**Report to
Development Permit Panel**

To: Development Permit Panel
From: Joe Erceg
Manager, Development Applications
Date: August 16, 2002
File: DP 02-202952
Re: Application by Darshan Rangi for a Development Permit at 9191 Blundell Road

Darshan Rangi has applied to develop a seven-unit project at the north east corner of Heather Street and Blundell Road, in the McLennan South Planning Area. The project consists of a five-unit building at the corner, with a coach house behind. The coach house contains six parking spaces accessible to the lane, with two units above. There is also a small amenity "exercise room", a children's play structure and two surface parking spaces in the development.

SITE LANDSCAPING PLAN

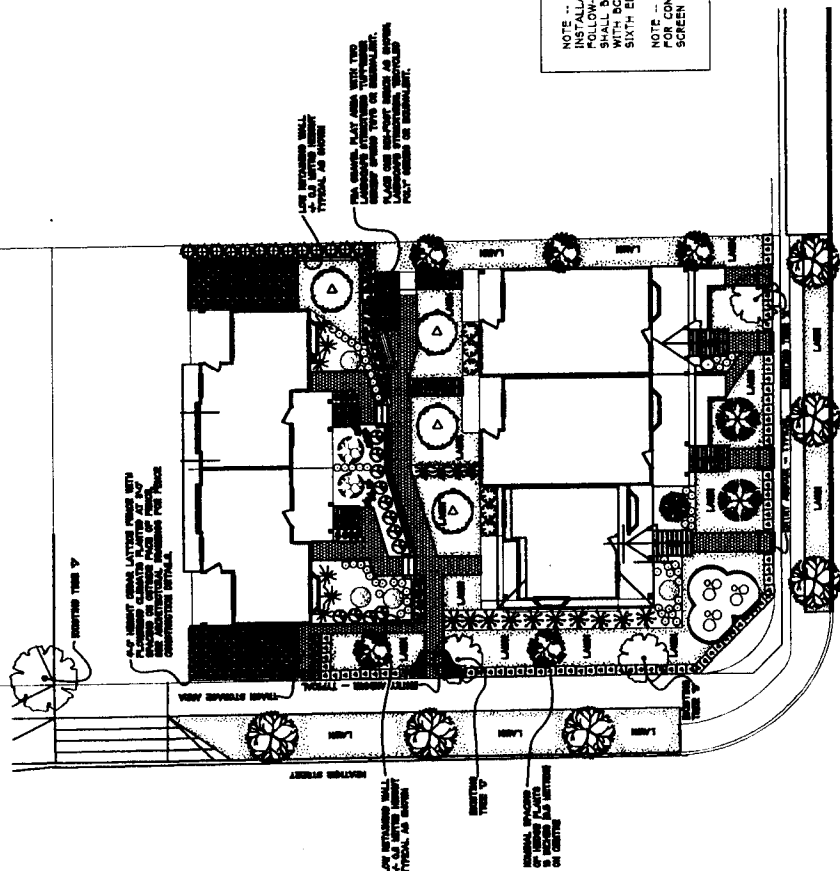
The garbage bin shown on the site plan is not necessary. Curb-side pickup would be more appropriate for this small project.

The existing trees on the site should be retained. The plant list should specify the number of plants. All wood fences, etc. should be stained or painted, two coats.

The applicant does not want to reduce the number of units or add ramping to the living space at grade. The landscape architect has screened the proposed garbage area and incorporated the existing trees into the plans.

2 EAST ELEVATION
1/4\"/>

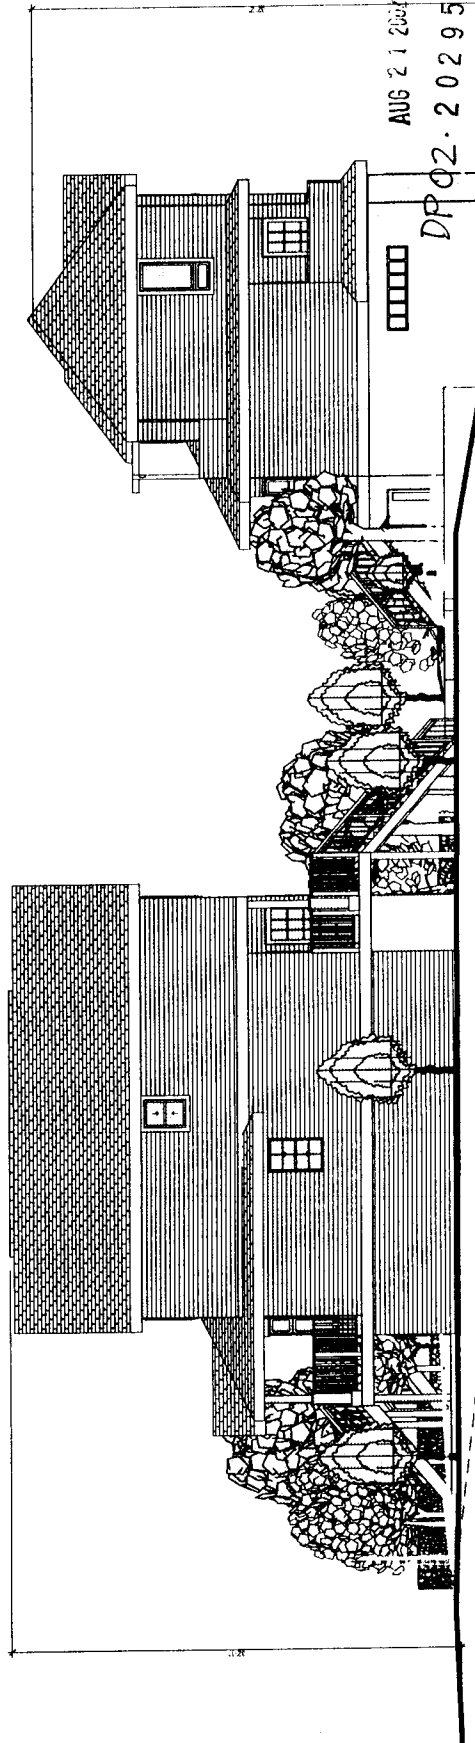
- ☒ Residential scale, operable, and with strong identity.
- ☐ Not flat, but bays, box widows, French balconies, trim, shutters, or similar features. **Windows on the east elevation appear somewhat flat.**
- ☒ Visible at sidewalk level and clear glass for surveillance.
- ☒ Traditional character, not bubbles or skylights visible from the street.

2 WEST ELEVATION
1/4" = 1'-0"

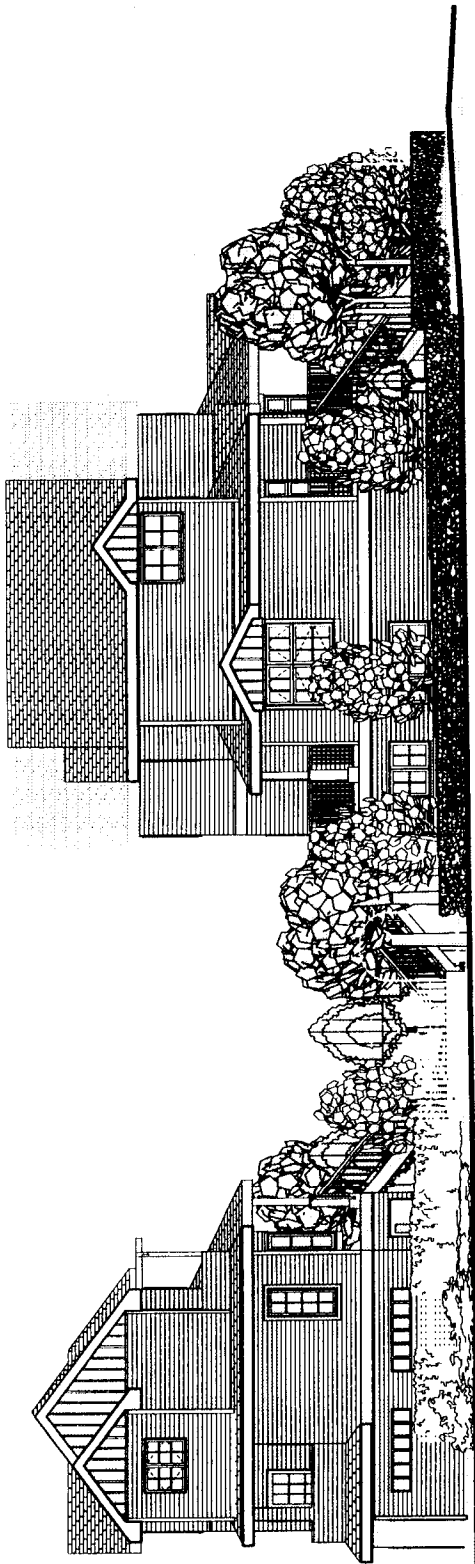
- The west elevation does not read like it is addressing the street; could be friendlier to the streetscape;
- Could turn a gable and get more trim on the outside
- The outdoor spacing between the two buildings must be fully developed to be successful;
- The use of materials was commended;
- The bathrooms are not accessible and should be to some degree;
- Sufficient space between the visitor parking stall and the sidewalk did not exist for the planned cedar hedge; screening or fencing was suggested;
- The arbour structure could require a stronger top section;
- The boxwood hedge should be planted 1 to 1.5 feet apart;
- Play areas should be required;
- The rear yards of south units should be defined to create separation between the yards and the common walkway;
